Frederick County Planning Commission

October 13, 2021

Lake Linganore Boulevard

Preliminary Plan

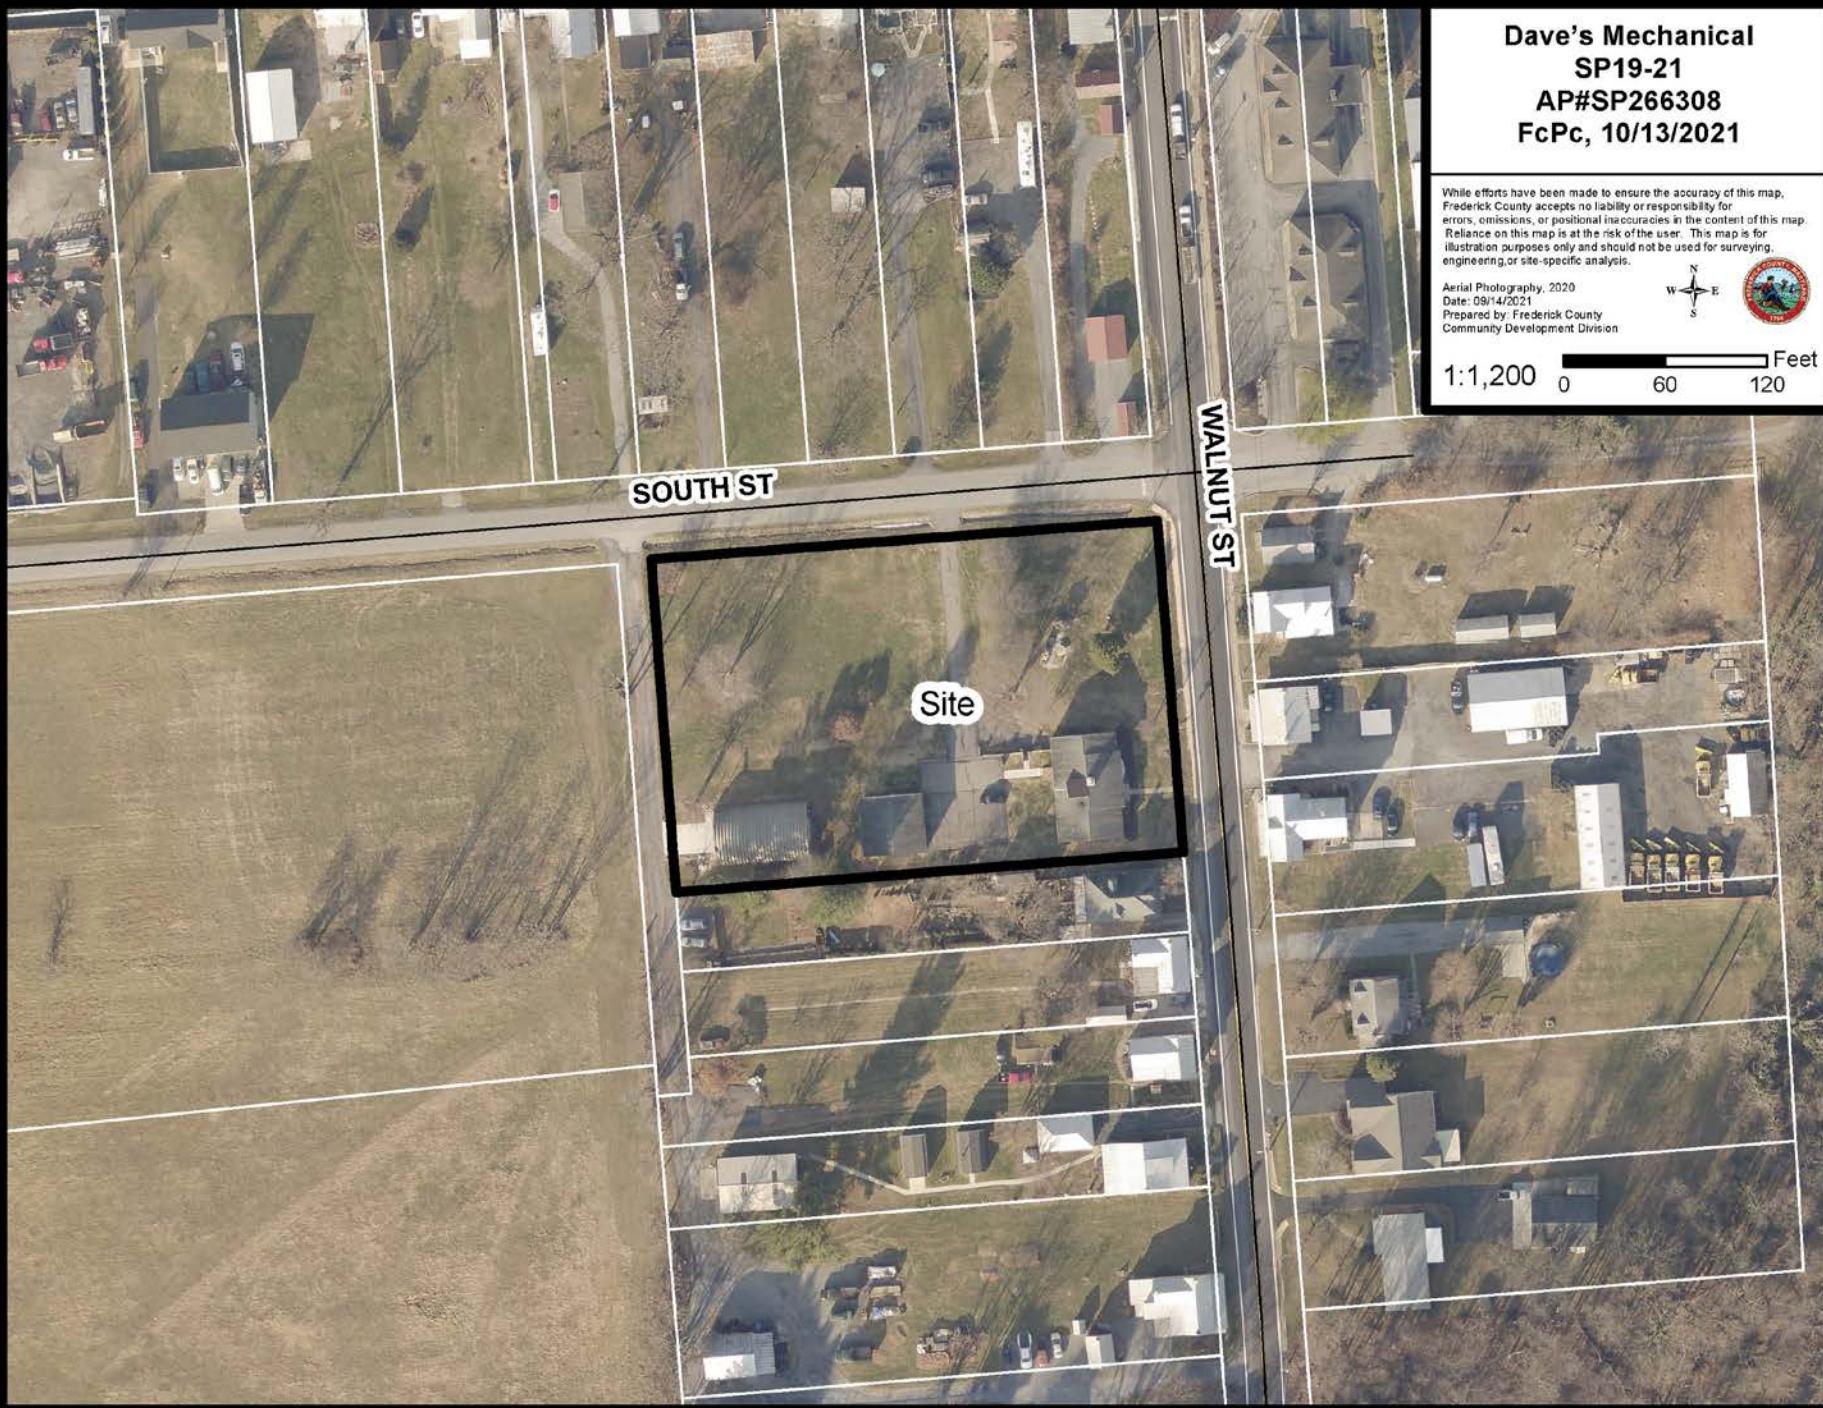
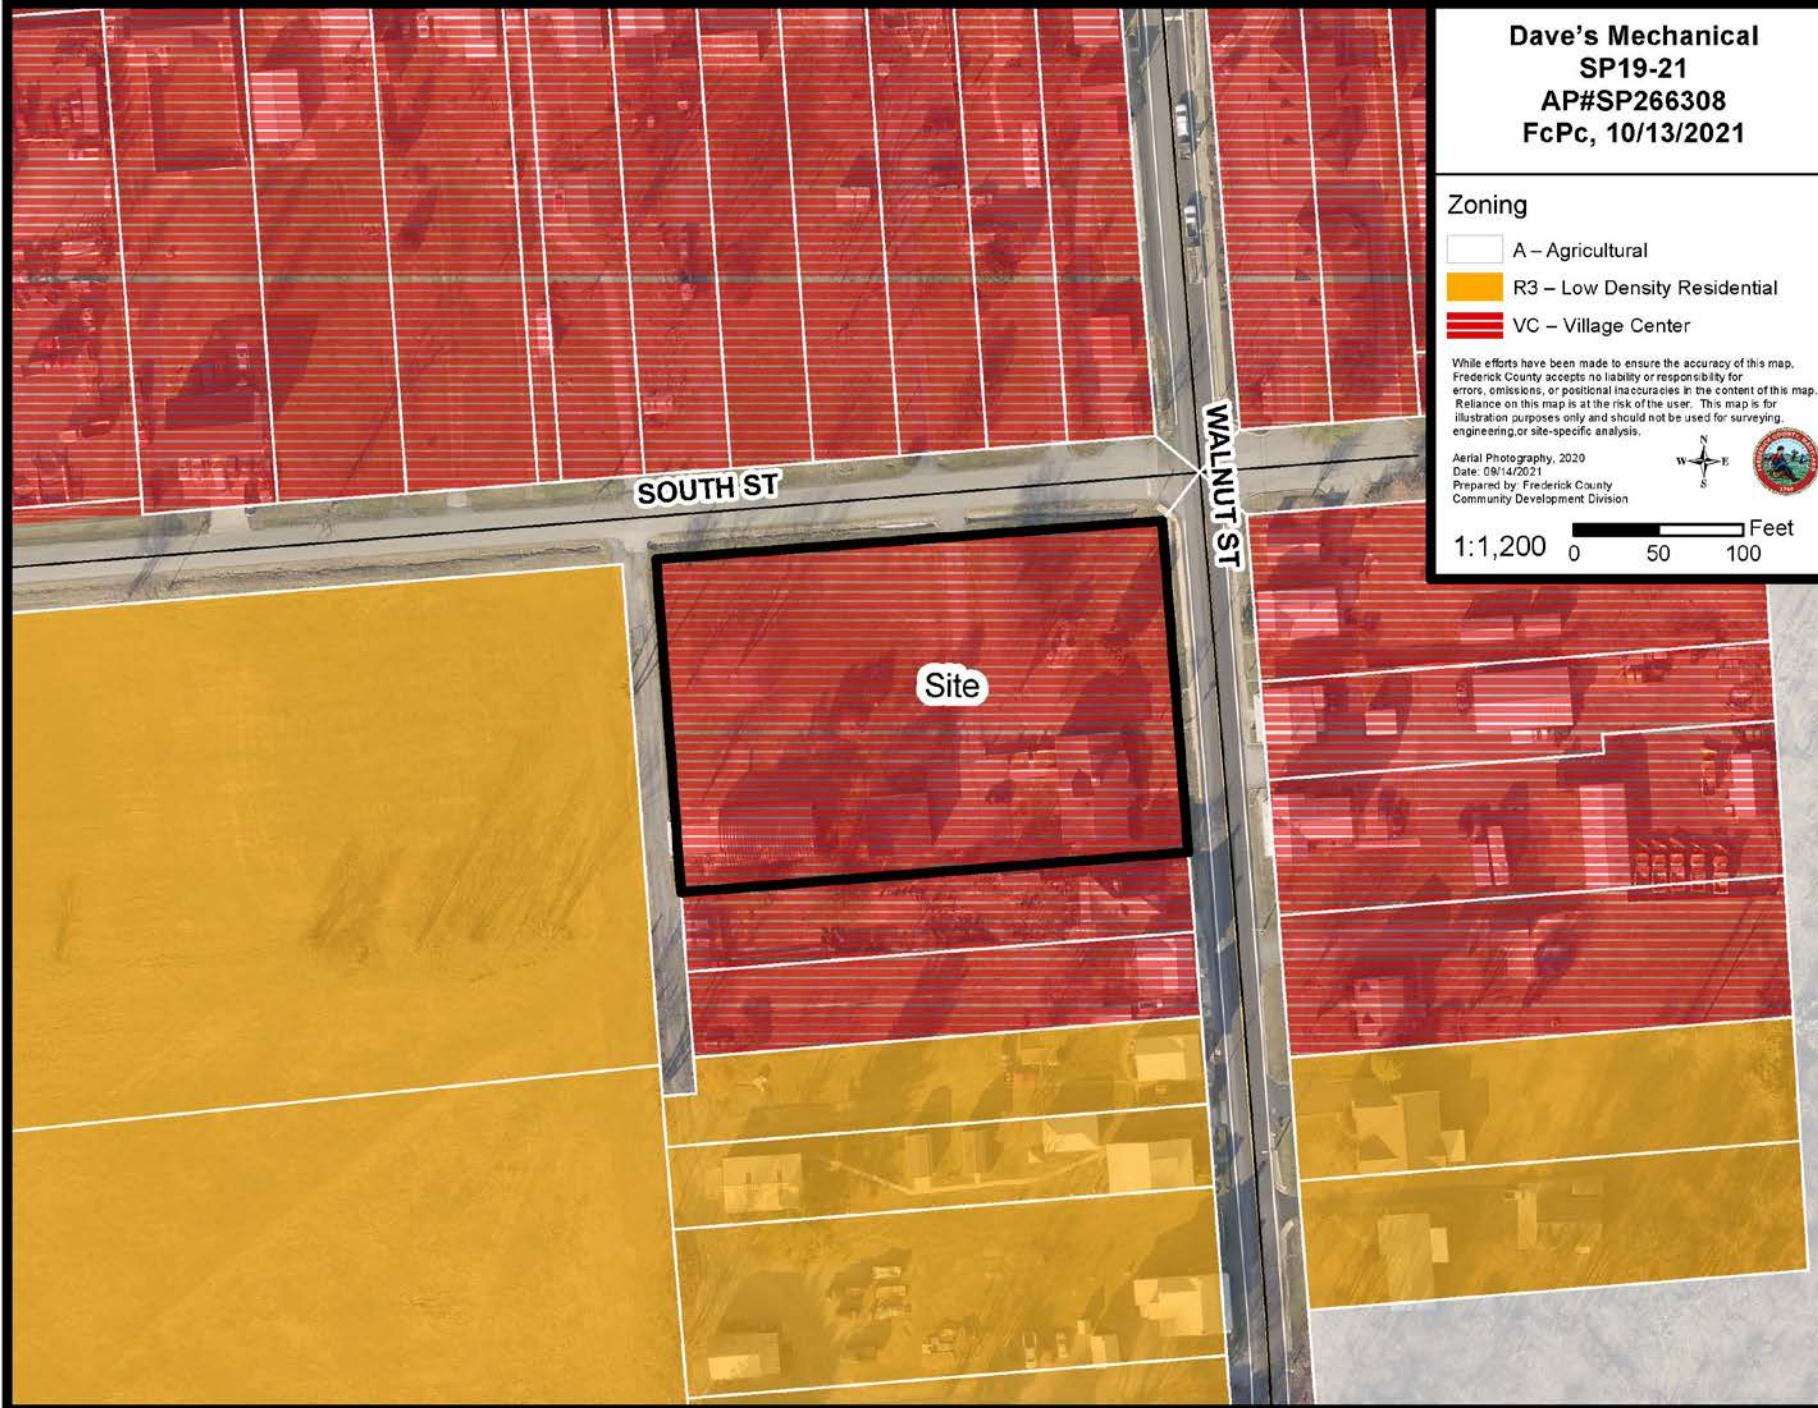
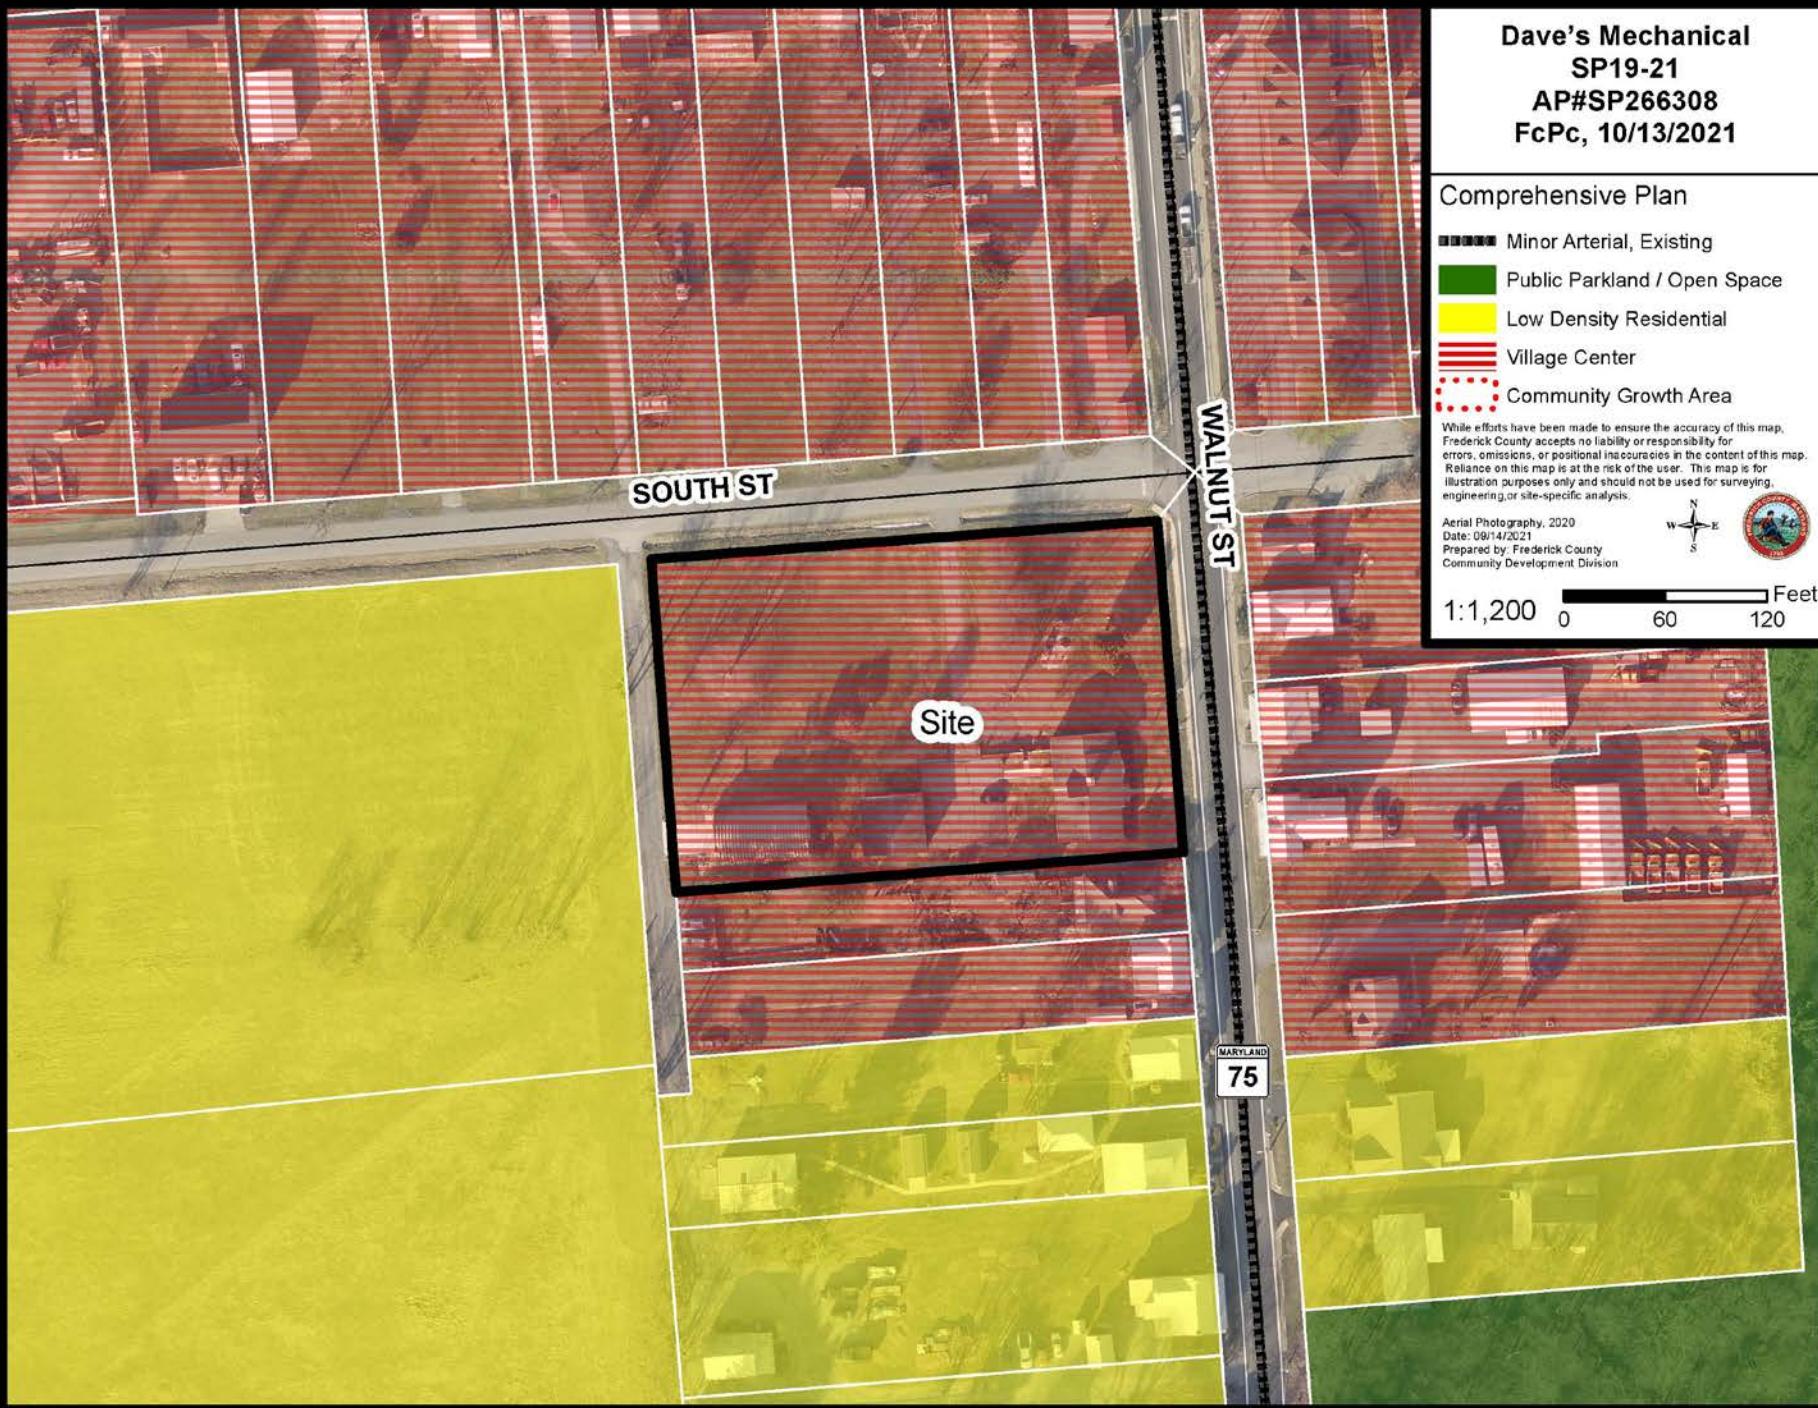
1. A lighting modification to allow light spillage on the areas shown on the lighting plan.

1. The Applicant shall comply with all Staff and agency comments through the completion of the plan.
2. Common access easement to be recorded and noted on the plan prior to final site plan approval.
3. The Addition Plat (PL266457) must be recorded prior to the Site Plan being stamped approved. The purpose statement on the Site Plan must be completed with the addition plat recordation information.
